VIRGINIA ELECTRIC AND POWER COMPANY
RICHMOND, VIRGINIA 23261

January 26, 1993

VIRGINIA ELECTRIC AND POWER COMPANY
SURRY POWER STATION UNITS 1 AND 2
SECOND TEN YEAR INSERVICE INSPECTION INTERVAL
RELIEF REQUESTS

**Surry Units 1 and 2
ISI Relief Requests**

VIRGINIA POWER
NORTH CAROLINA POWER
NUCLEAR ENGINEERING SERVICES
RICHMOND, VIRGINIA
ISI CLASSIFICATION BOUNDARY DRAWING
CIRCULATING AND SERVICE WATER SYSTEM
SURRY POWER STATION UNIT 1
VIRGINIA POWER

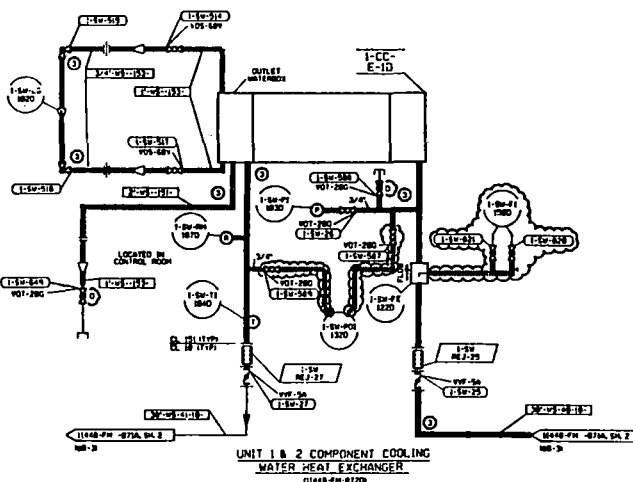
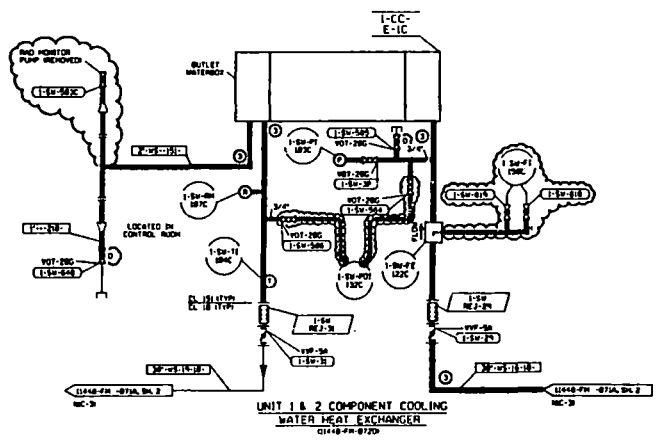
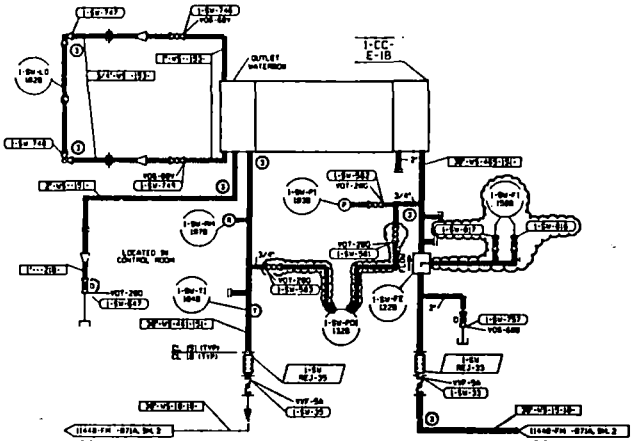
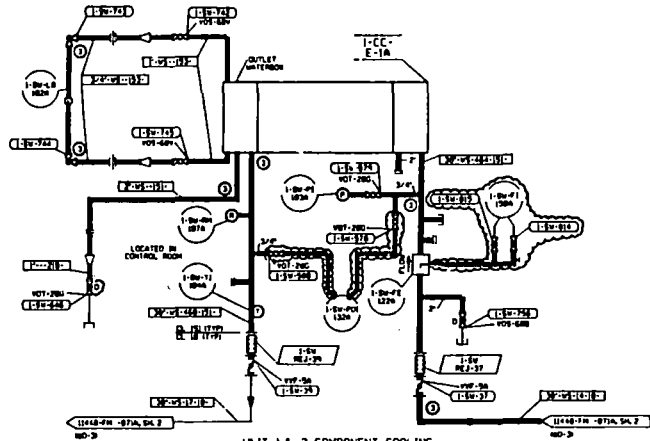
ISI Class 3 System Hydrostatic Test as required by IWD-5223 of ASME Section XI, where the design pressure is 25 psig and the corresponding test pressure is 28 psig.

Technical Specification 3.14 requires service water flow to and from the component cooling water heat exchangers. One unit operation requires two component cooling water heat exchangers, while two unit operation requires three component cooling water heat exchangers. Additionally Technical Specifications 3.5 and 3.10 provide requirements associated with component cooling operability for core residual heat removal in both unit operation and refueling modes. The identified supply header to the component cooling water heat exchangers is the only source of cooling water to these components. Conducting the Code required hydrostatic test would require isolation of all four component cooling water heat exchangers, placing the unit(s) in conflict with Technical Specifications as previously discussed.

The lines and components identified are gravity fed from the in-take canal from lines providing water to the main condensers. As an alternative, a system inservice test to the requirements of IWD-5221 and the corresponding visual (VT-2) examination of the accessible areas will be conducted in lieu of the Code hydrostatic test.

ISI CLASSIFICATION BOUNDARY DRAWING
MAIN STEAM SYSTEM
SURRY POWER STATION UNIT 1
VIRGINIA POWER

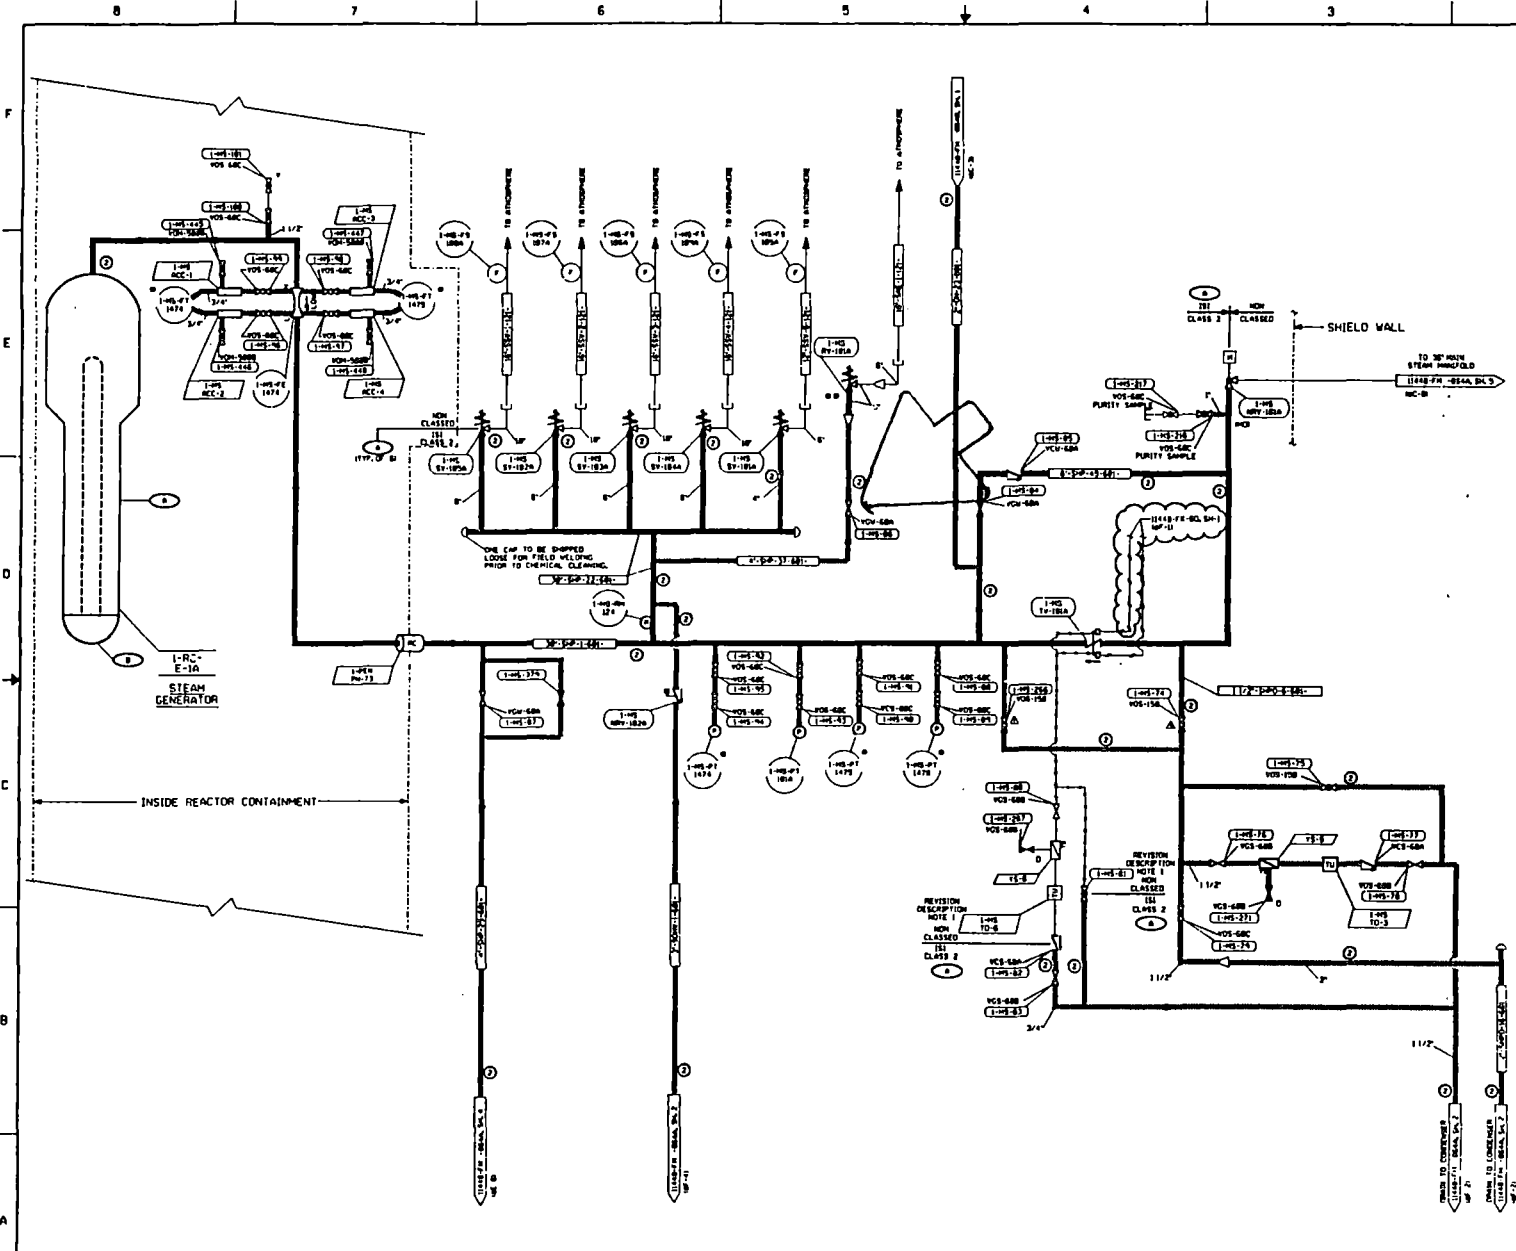
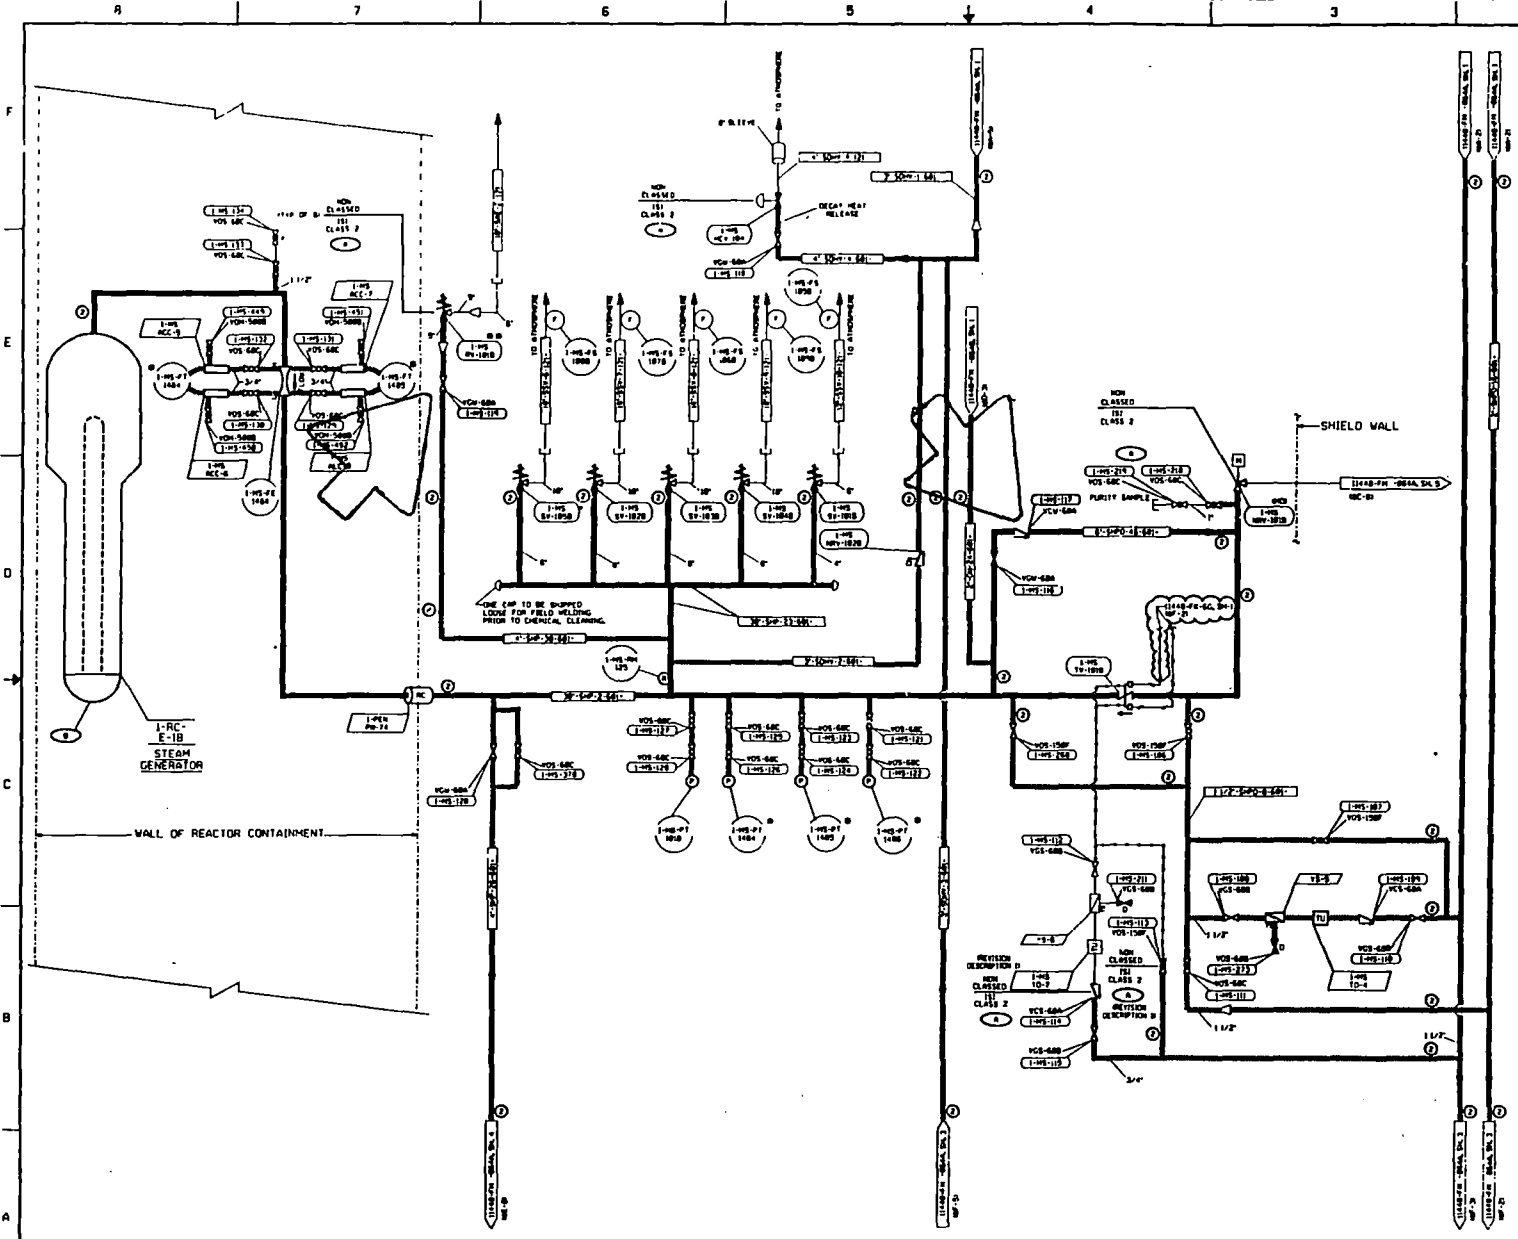
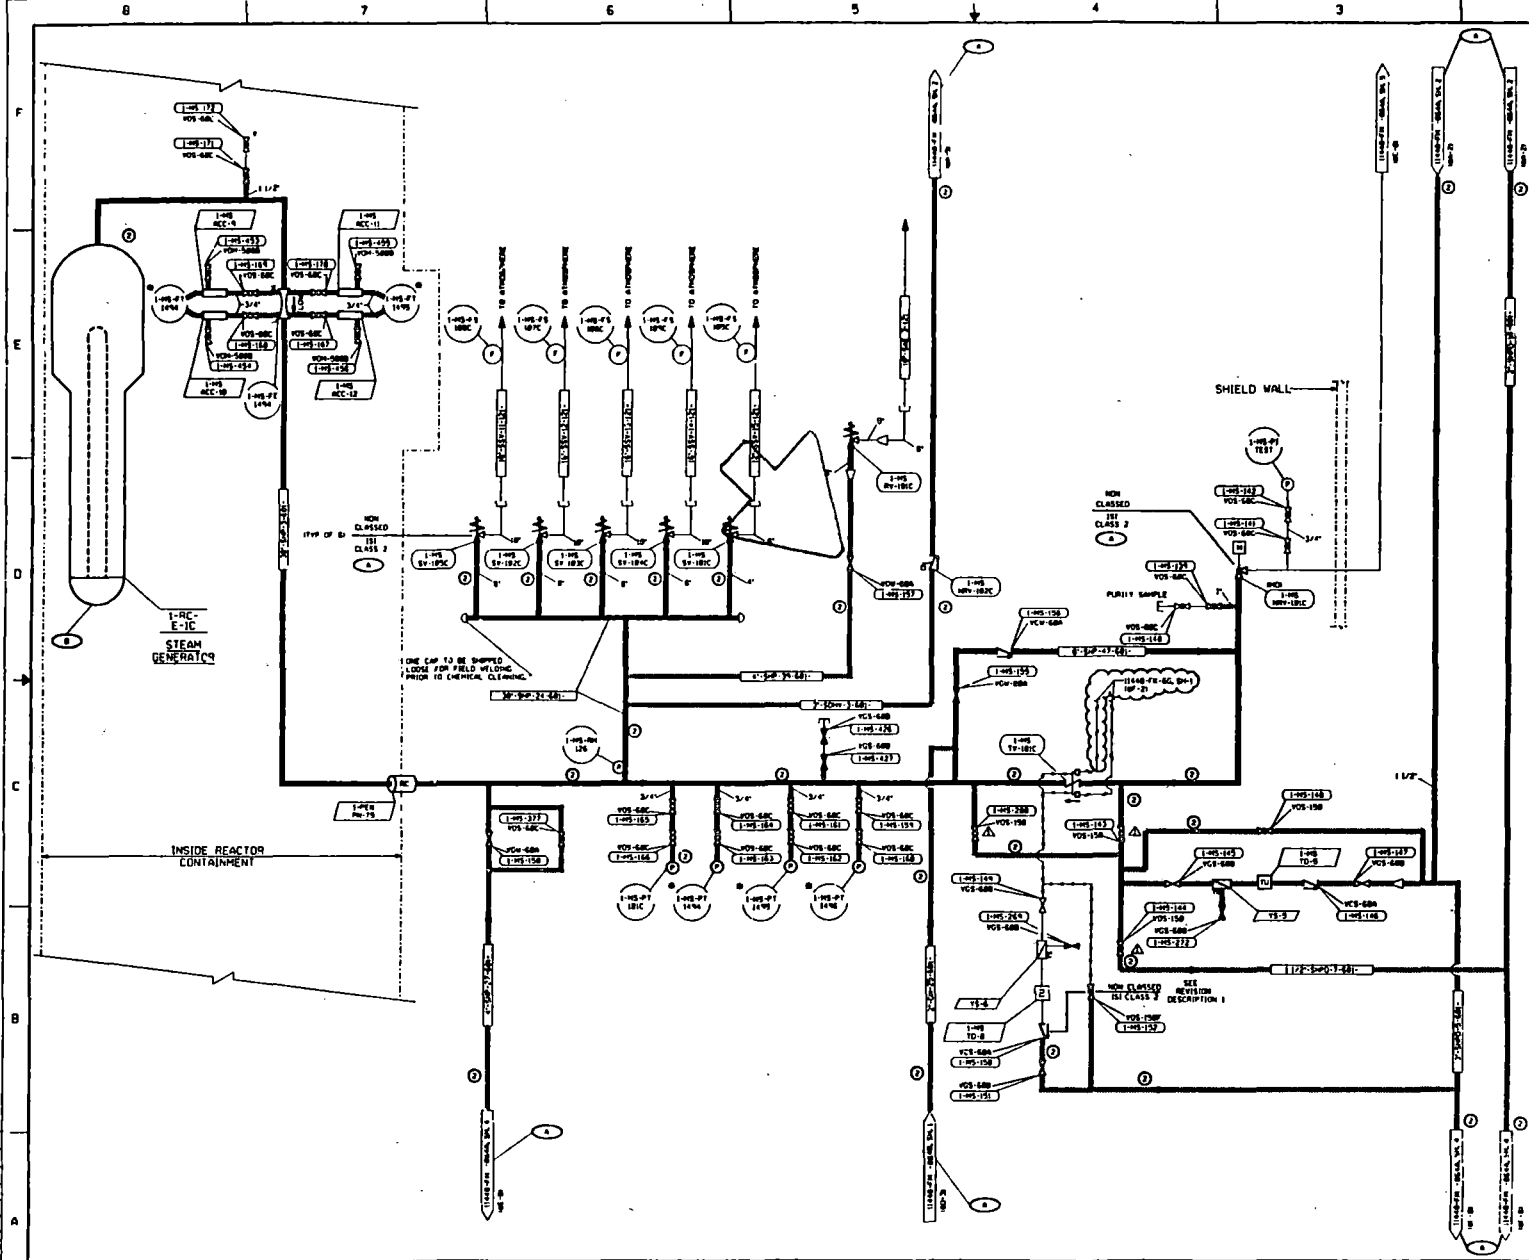
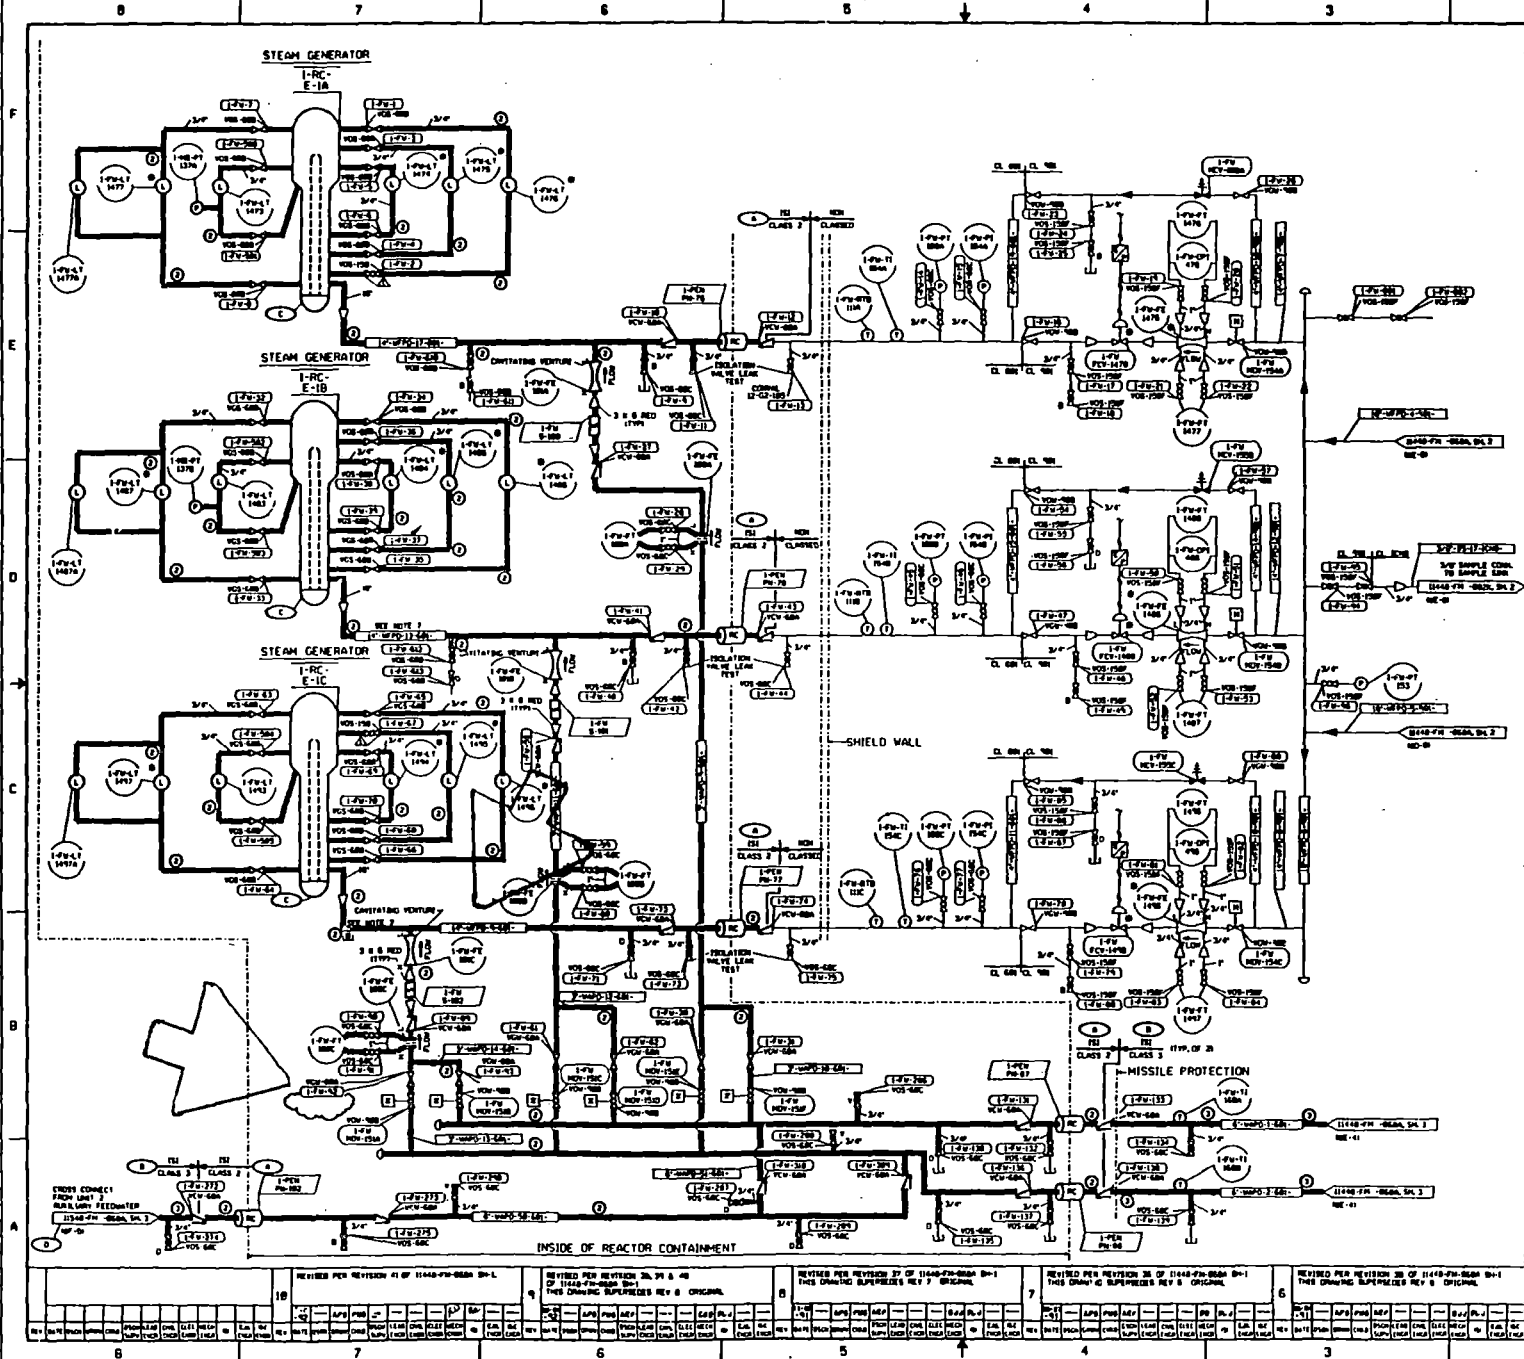
Surry Unit 1 utilized Code Case N-416, Alternate Rules for Hydrostatic Testing of Repair or Replacement of Class 2 Piping Section XI, Division 1, on the components identified above. This Code Case defers the hydrostatic test required by IWA-4400 of ASME Section XI until the next regularly scheduled system hydrostatic test (IWC-5000) for that system.

The identified components were replaced under the rules of ASME Section XI. IWA-4400 of the Code requires that a hydrostatic test be conducted on certain welded repairs or replacements. These replacements cannot be hydrostatically tested without also hydrostatically testing the connecting steam generator, as no intermediate isolation exists. Valve 1-MS-117 appears to have intermediate isolation, however the main steam trip valve, 1-MS-TV-101B, acts like a check valve, and would open during pressurization to the steam generator.

pressure of 1356 psig also requires gaging or removal of the Main Steam Safety valves, which initially lift at 1085 psig. Some examples of previous correspondence requesting relief and approval follow:

The alternative requirements described in Code Case N-416, a volumetric examination of the full penetration welds and a visual examination (VT-2) at nominal operating pressure was previously performed and deemed acceptable.
